GRAND GULF NUCLEAR STATION
UNIT 1

RELIEF REQUEST I-00002, REVISION 3

INSERVICE INSPECTION
OF PRESSURE RETAINING WELD IN SCRAM DISCHARGE VOLUME PIPING

GRAND GULF NUCLEAR STATION
INSERVICE INSPECTION
TEN YEAR PROGRAM

FIGURE 6
SCALE: 1/10

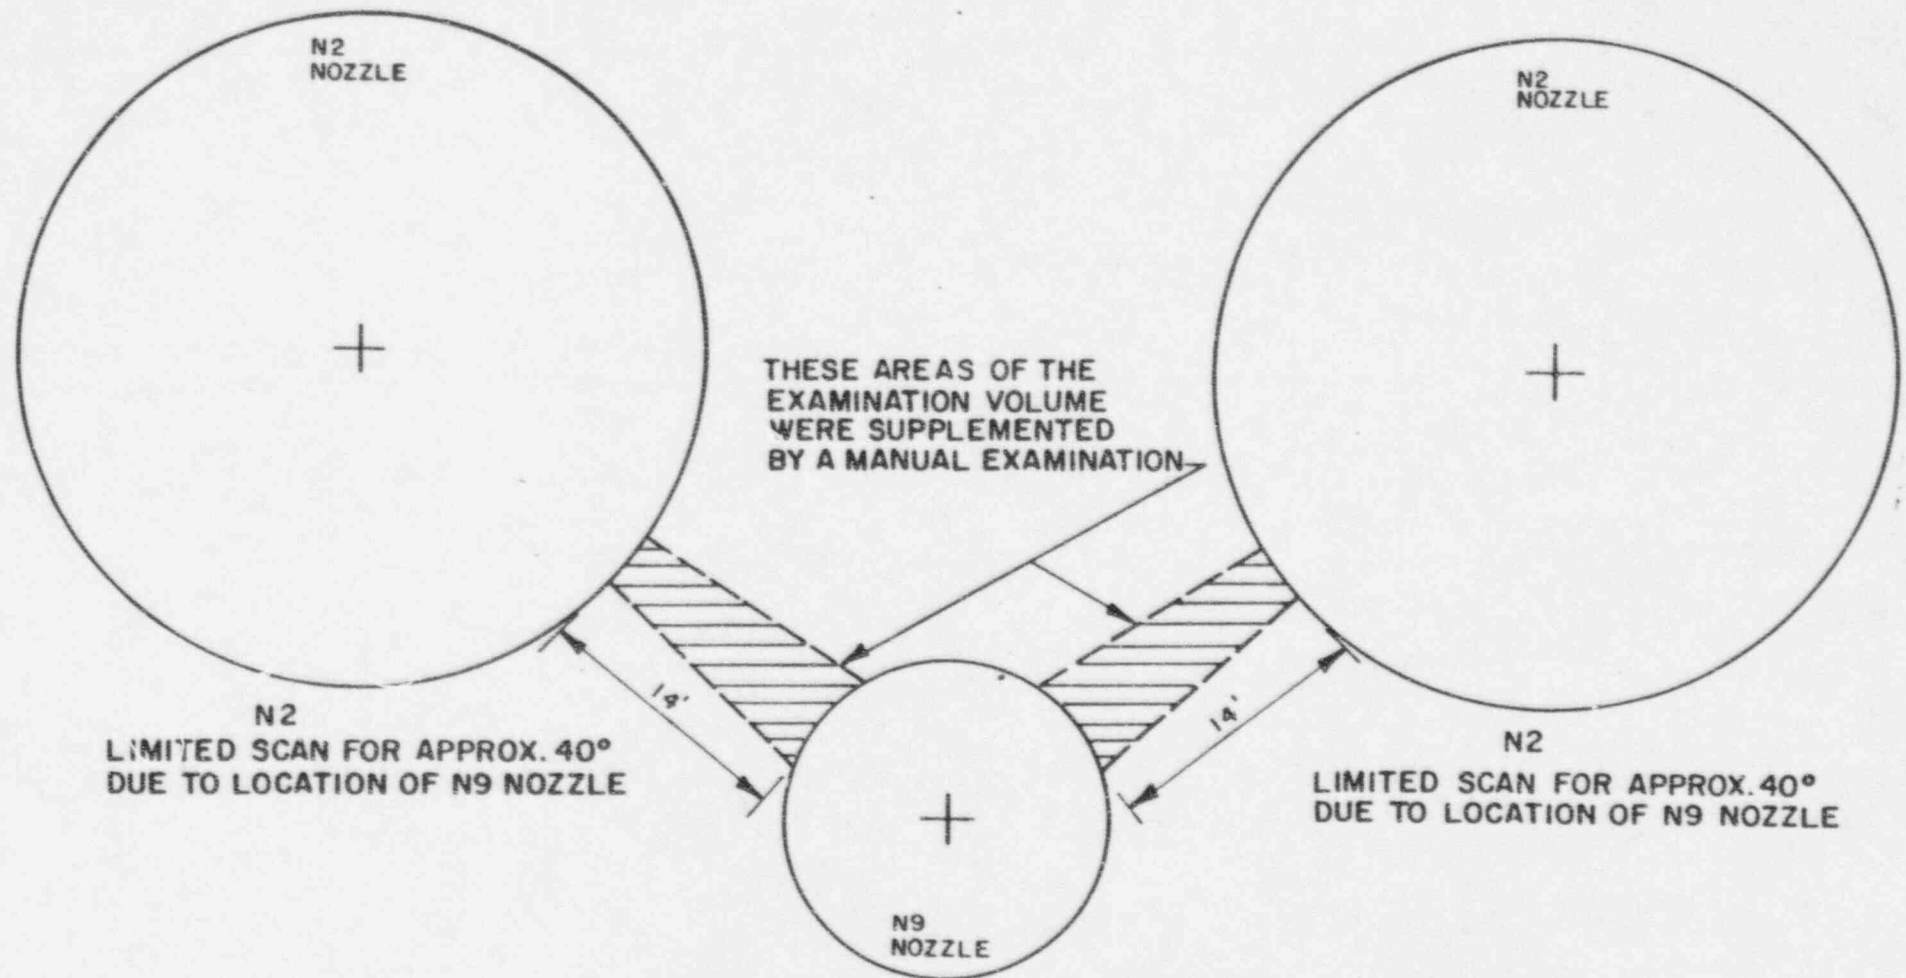
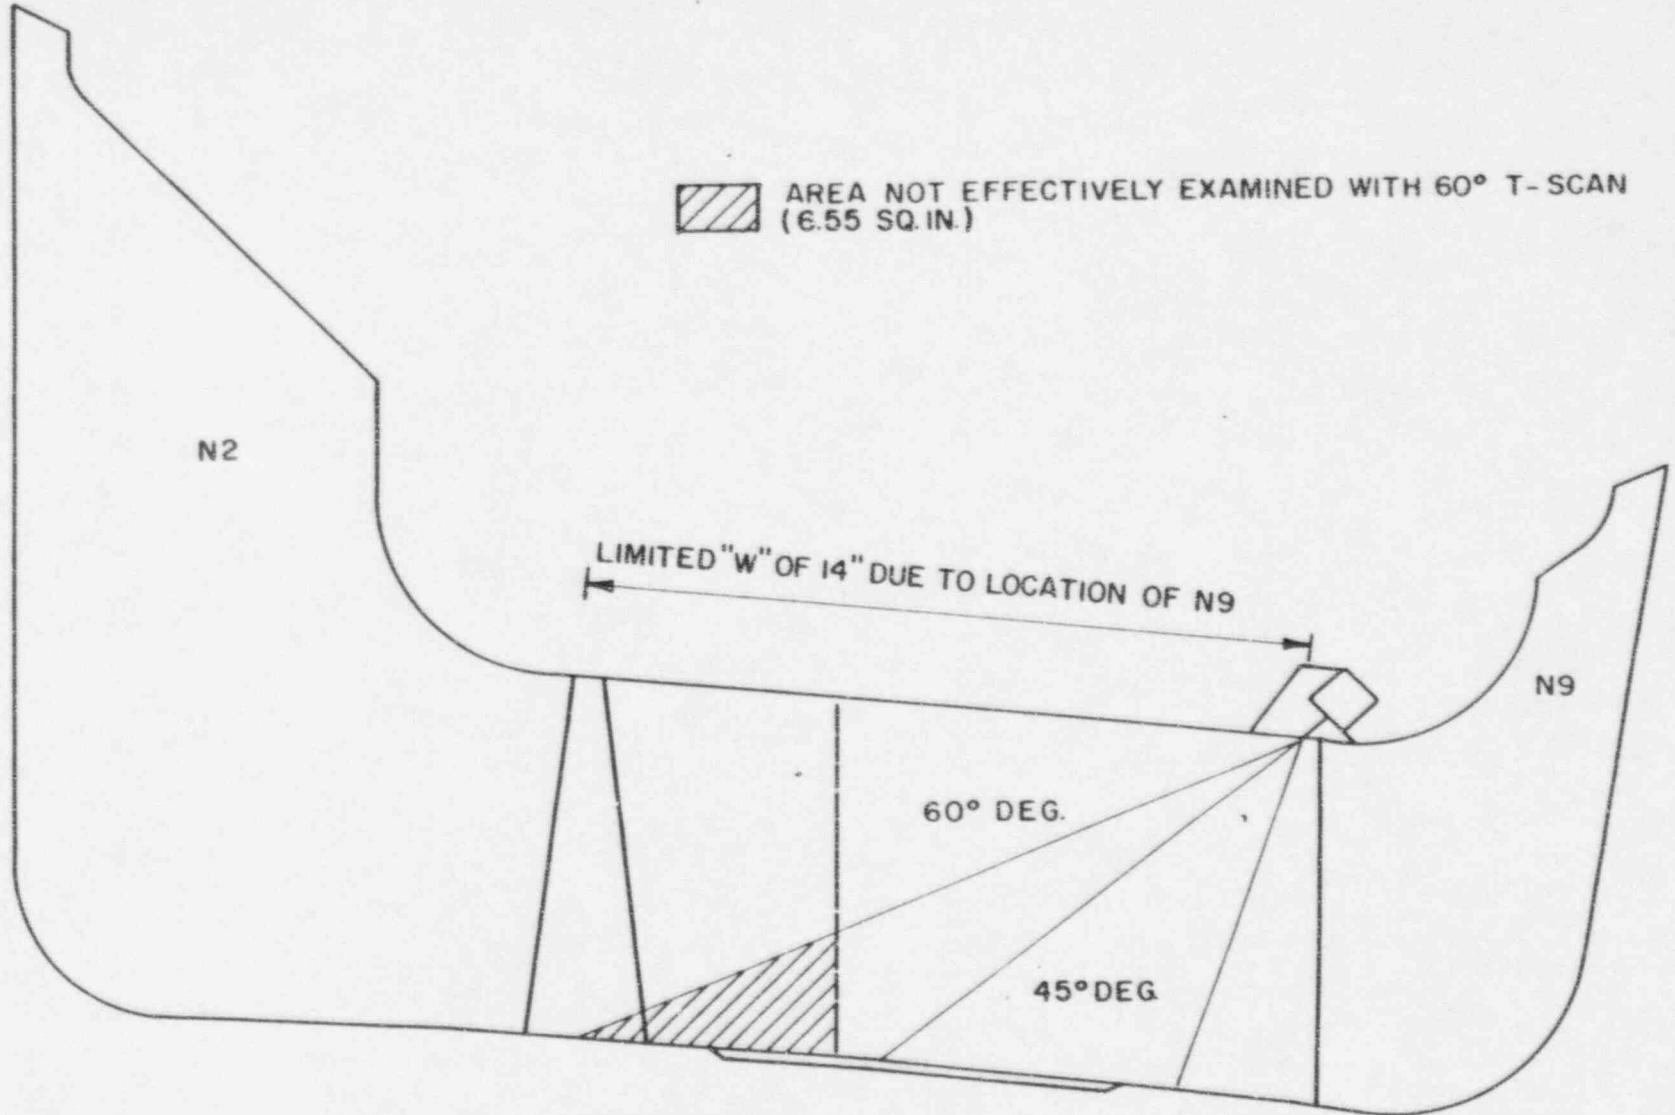
<u>WELD I.D.</u>	<u>CODE CATEGORY</u>	<u>ITEM NO.</u>	<u>DESCRIPTION OF EXAMINATION LIMITATION</u>
Nozzles; N4A, N4C, N4D, N4F	B-D	B3.90	The N4 nozzles are located on shell ring no. 3, 17" from the N13 nozzles. The close proximity of the N13 nozzles limits the automated examination to a "W" dimension of 14" for approximately 44° of the N4 nozzles circumference. This limitation prevents the 60° T-Scan from examining all of the required code volume (see Figure 5). Supplemental manual 60° examinations would obtain coverage of the limited area; however, due to the radiation levels encountered at the first refuel outage (3 R/hr) and the fact that the volume not examined by the 60° scan is examined by the 45° T-Scan, 45° and 60° P-Scan and the 0° scan, it is not practical to perform the supplemental examinations.
Nozzles; N2D, N2C, N2J, N2K	B-D	B3.90	Examination of 4 recirculation inlet nozzles is limited due to interferences from the two N9 Jet Pump Instrument nozzles located approximately 14" from the affected N2's. This portion of the circumference that is not accessible to the automated scanner is examined manually, but the 14" limitation prevents complete coverage with the 60° T-Scan (see Figure 6).

FIGURE 7.
SCALE: 1/10
PAGE 1 OF 2

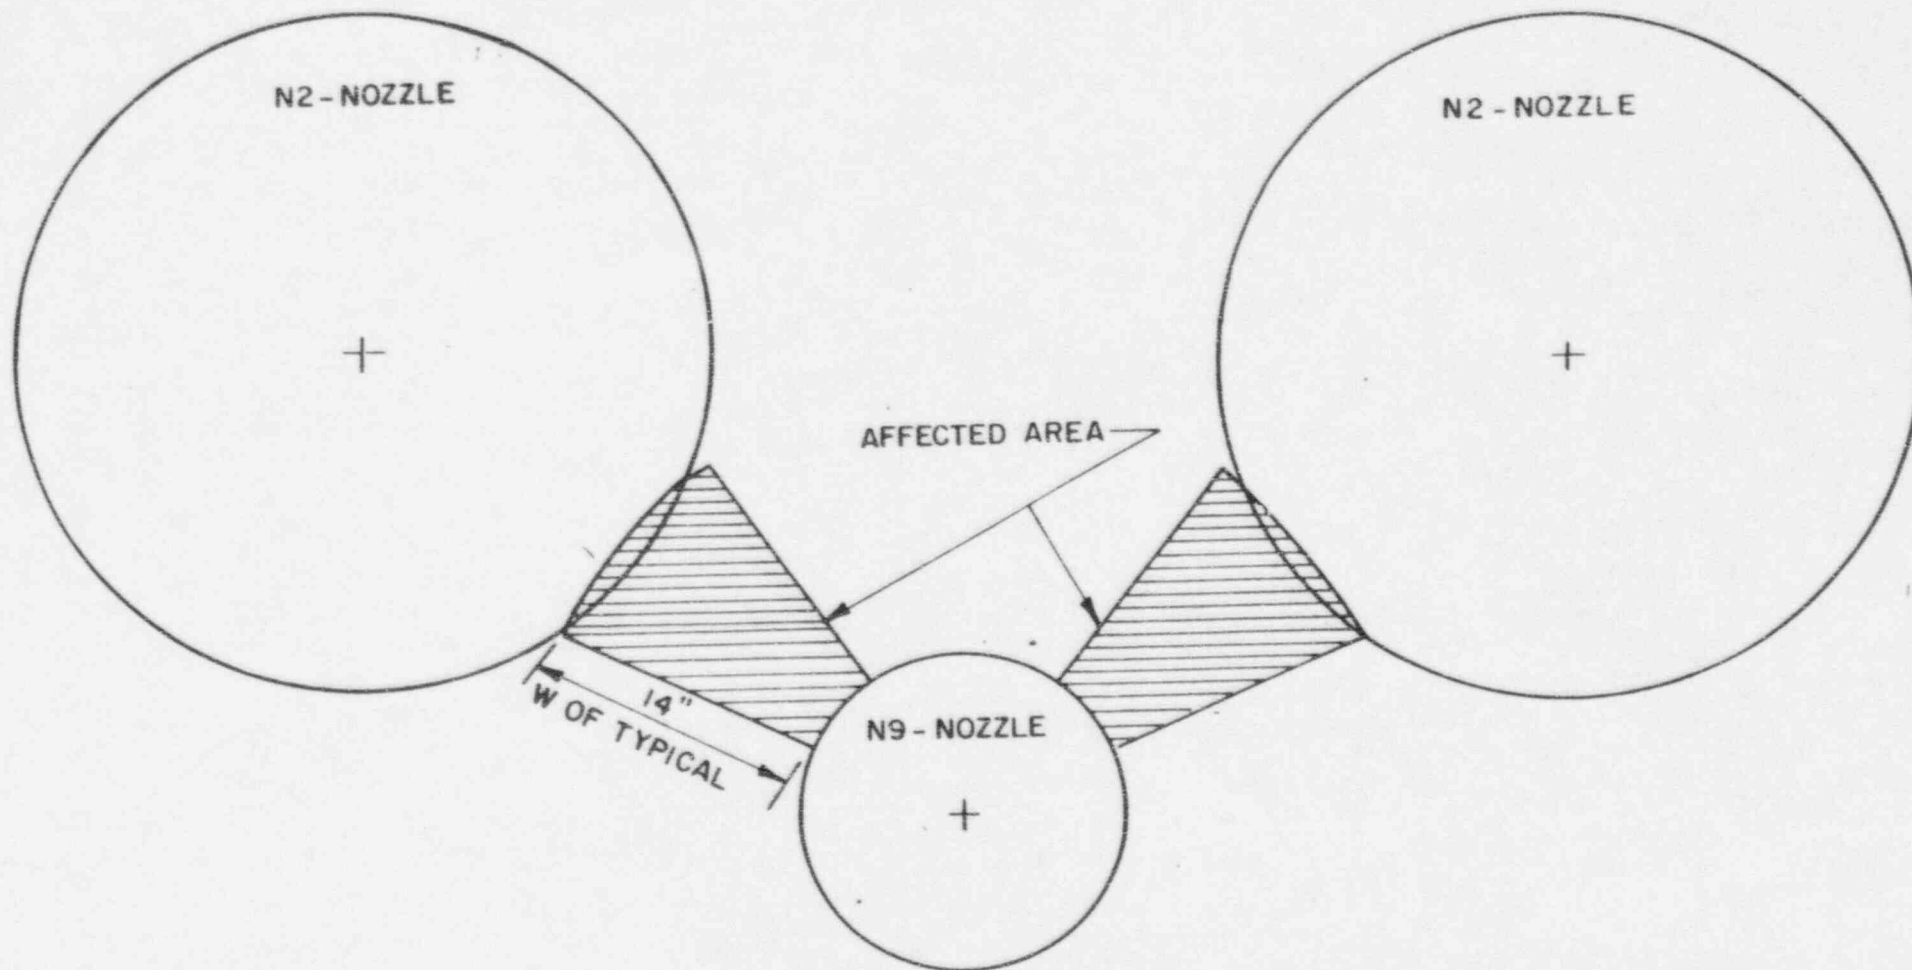
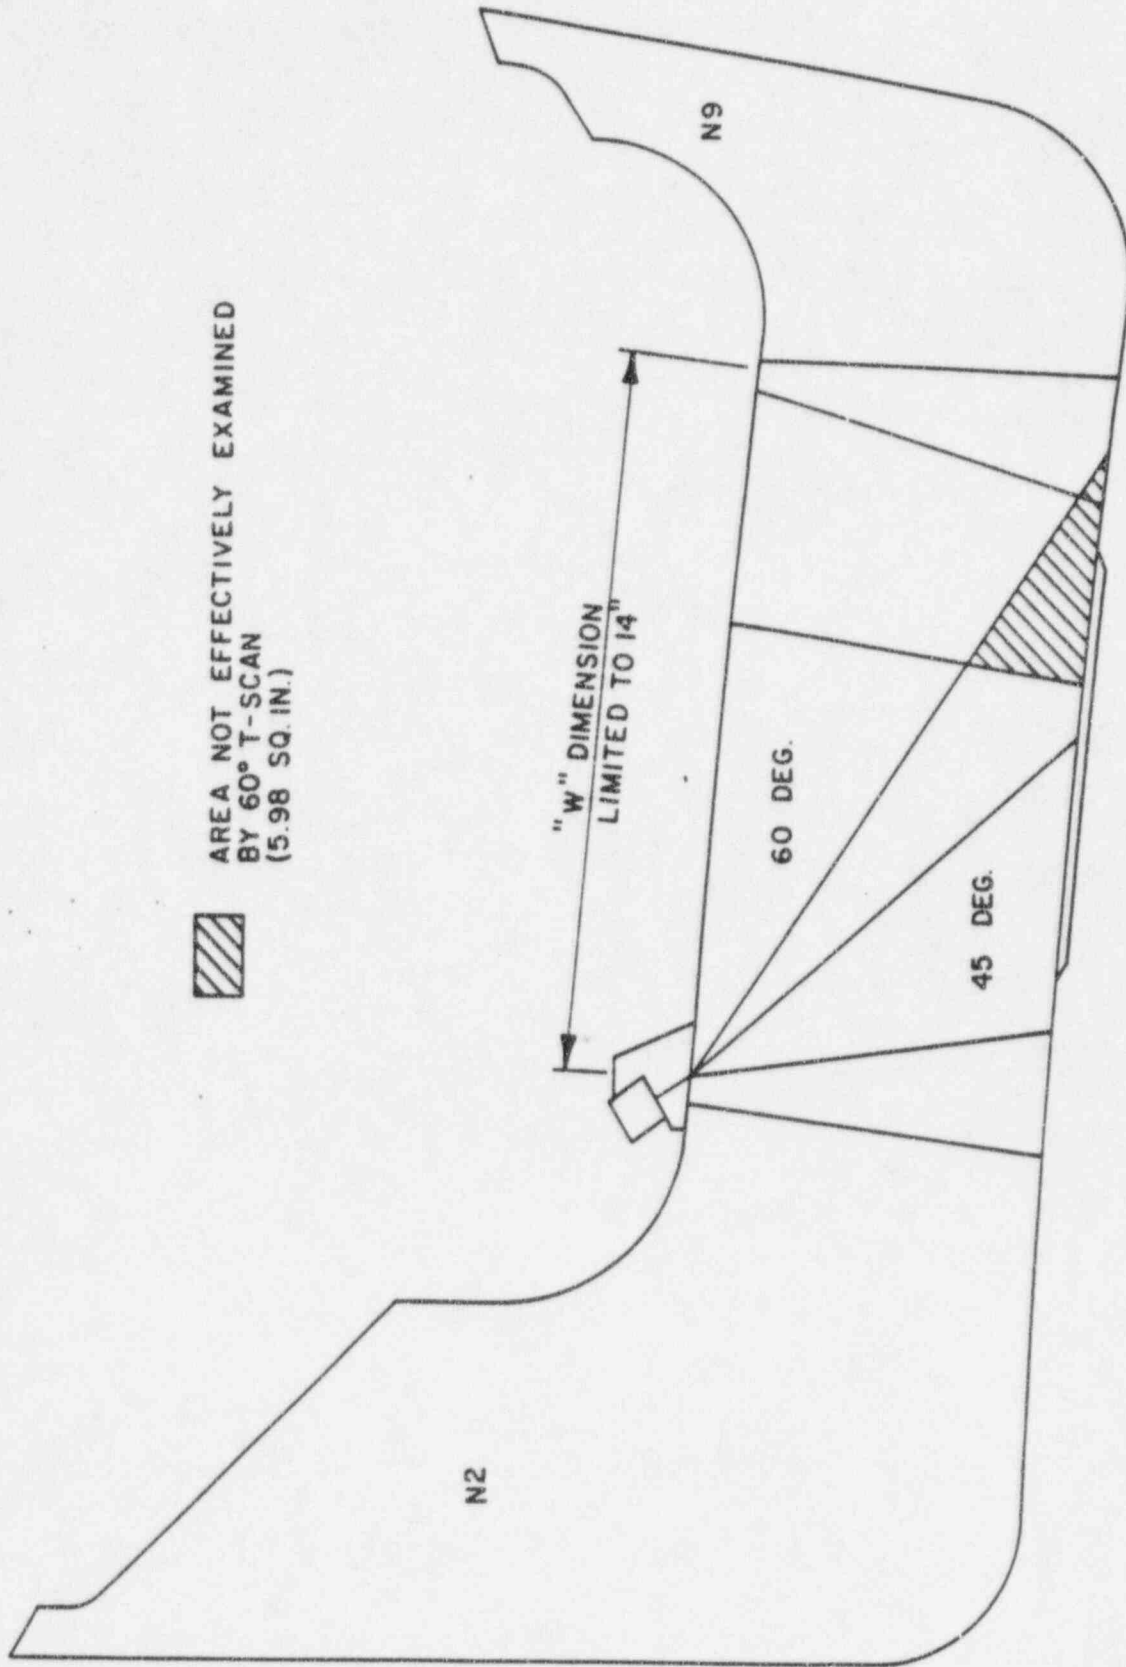
Nozzles; N9A, N9B	B-D	B3.90	The two N9 nozzles are located between and just below four of the N2 nozzles creating the same limitations for the N9 nozzles as discussed above for the N2's (see Figure 7).

FIGURE 14

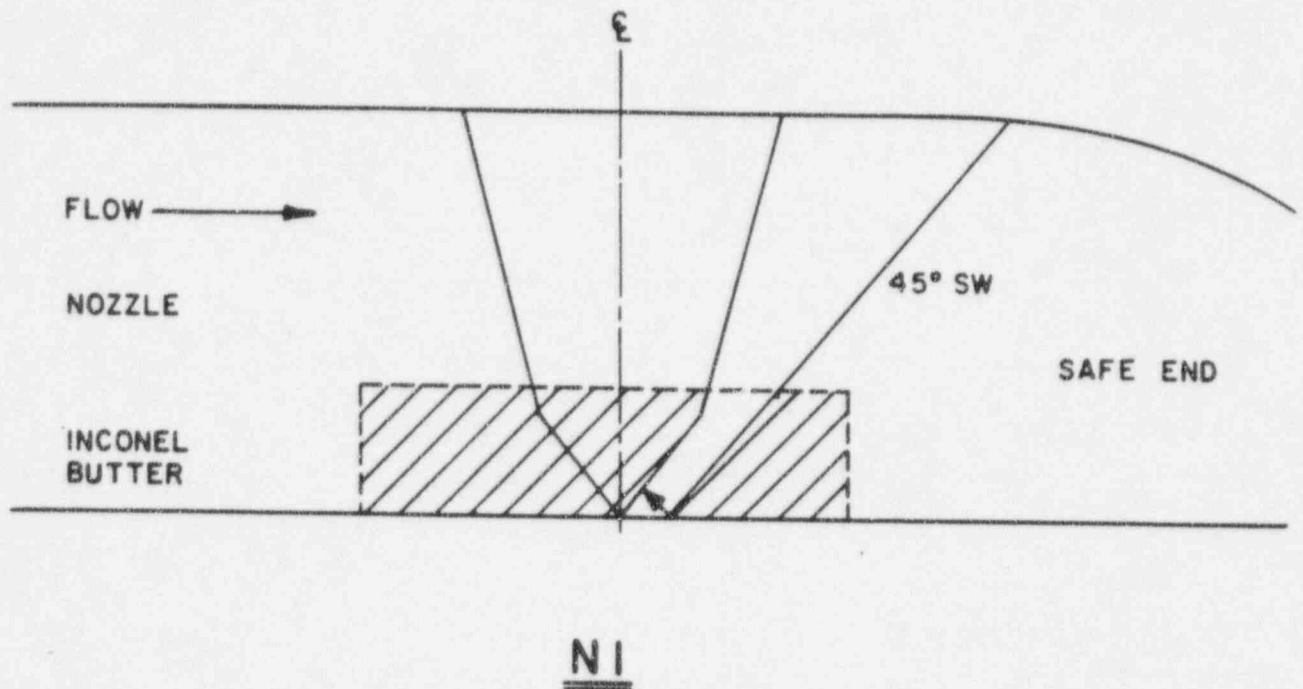
N1
RECIRCULATION OUTLET NOZZLE TO SAFE END WELD
LIMITATIONS

Total code volume at a cross-sectional view is 0.95 in².

- Automated techniques utilizing a 45° shear wave obtains two-directional coverage of an area equal to 0.17 in².
- Also, a 45° and 60° refracted longitudinal (RL) wave is utilized that obtains one-directional coverage of the entire code volume scanning from the nozzle side.
- The cross-hatched area received the one-directional coverage from the nozzle side, the remaining area was examined from two directions utilizing the shear wave.
- Manual examinations will provide two-directional coverage of the weld and nozzle base material, the available "W" dimension on the safe end side of the weld is insufficient to obtain full coverage of the safe end material.

FIGURE 15

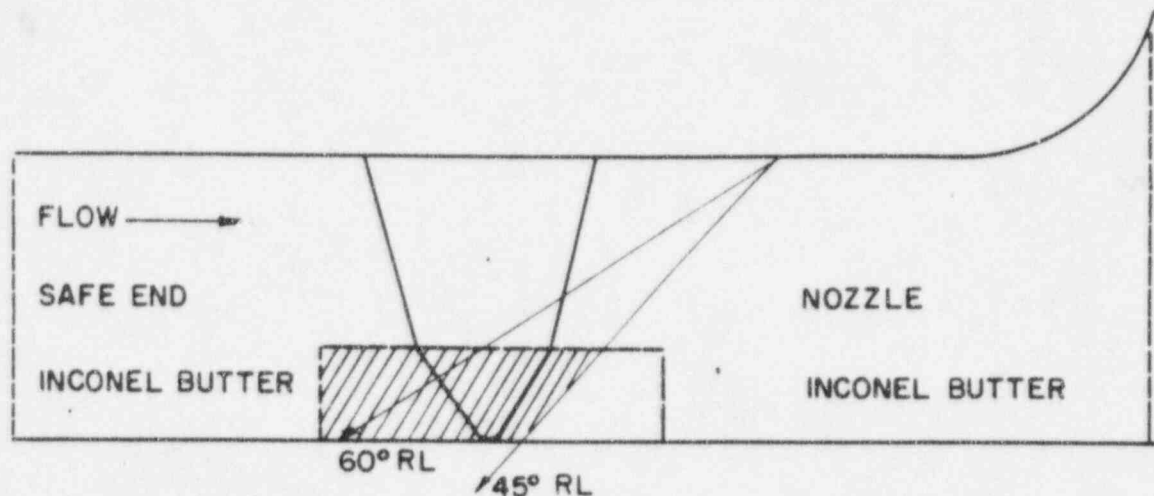
N2
RECIRCULATION INLET NOZZLE TO SAFE END WELD
LIMITATIONS

- Automated techniques utilized a 45° and 60° RL wave for the examination of the N2F and N2H to obtain complete code volume coverage from one direction with both angles.
- The remaining N2 nozzles (A, B, C, D, E, G, J, K, M, N) were examined completely from one direction with only the 60° due to excessive noise received with the 45° transducers.
- Manual examinations can provide two-directional coverage of the area represented by the cross-hatching, this would improve total code coverage to 0.271 in² or 32% for the 60° and 0.642 in² or 75.6% for the 45°.
- If the presently available 45° transducers are improved to reduce noise levels, future examinations will include the 45° for improved coverage.

FIGURE 16

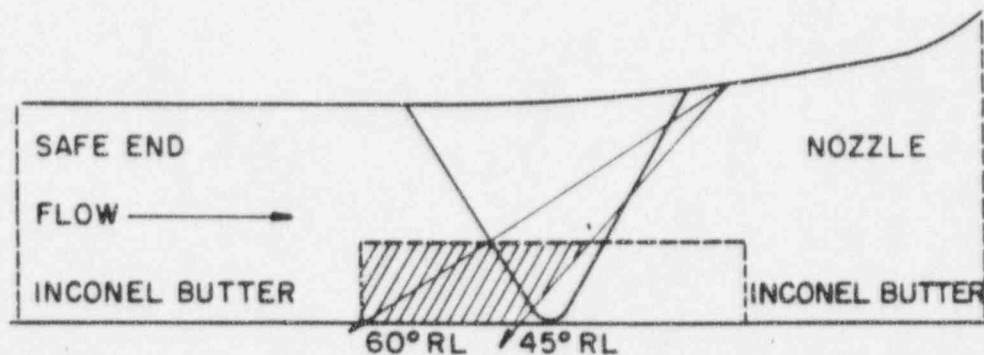
N4
FEEDWATER INLET NOZZLE TO SAFE END WELD
LIMITATIONS

- Automated techniques utilizing a 45° and 60° RL wave obtained coverage of the code volume from one direction only (safe end side).
- Manual examinations will provide coverage from two directions for the area identified above by the cross-hatching, 0.36 in² or 51.4% of the total code volume.

FIGURE 17

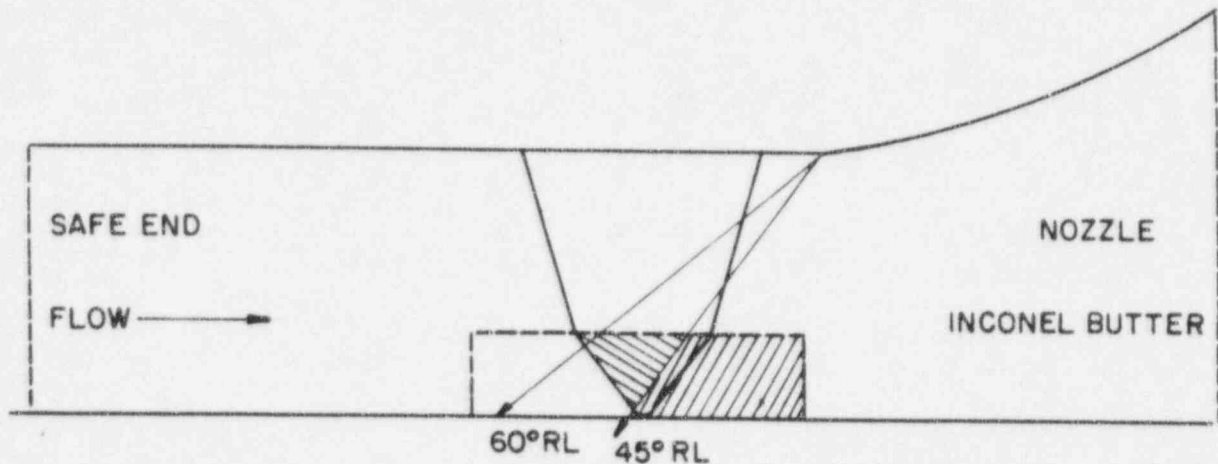
N5
CORE SPRAY TO SAFE END WELD
LIMITATIONS

- Automated techniques provide a 45° shear wave from the safe end side, obtaining two-directional coverage of an area equal to 0.33 in² or 46.6% of the total code volume.
- Also, a 45° and 60° RL wave examination from the safe end side is performed, obtaining one-directional coverage of the total code volume. Area receiving examination from one direction only is 53.4% of the code volume.
- Manual examinations with RL wave will increase two-directional cover by 18%.

FIGURE 18

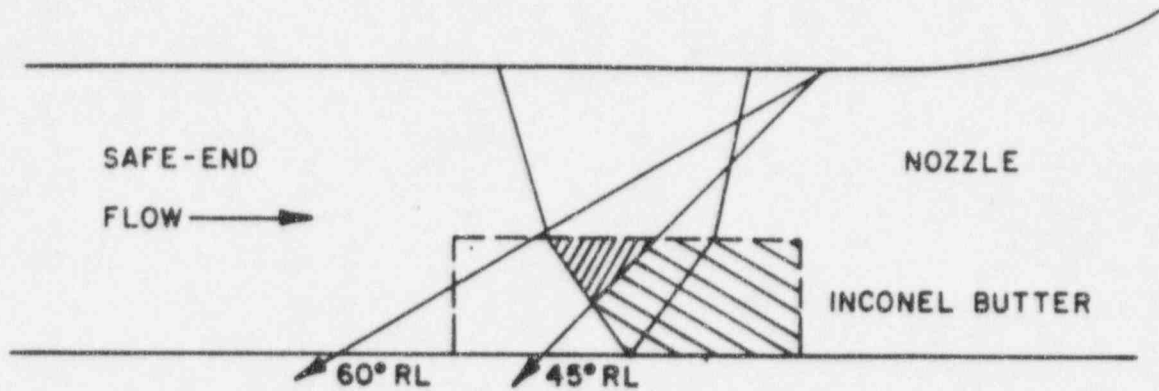
N6
RESIDUAL HEAT REMOVAL / LOW PRESSURE CORE INJECTION
SAFE END TO NOZZLE WELD
LIMITATIONS

- Automated techniques provide a 45° shear wave examination from the safe end side, obtaining two-directional coverage of 0.34 in² or 36.6% of the total code volume.
- Also, 45° and 60° RL wave examinations performed from the safe end side obtain one-directional coverage of the total code volume; area receiving one-directional coverage only is 0.59 in² or 63.4% of the code volume.
- Manual examinations will increase two-directional coverage by 9.7% or 0.09 in².
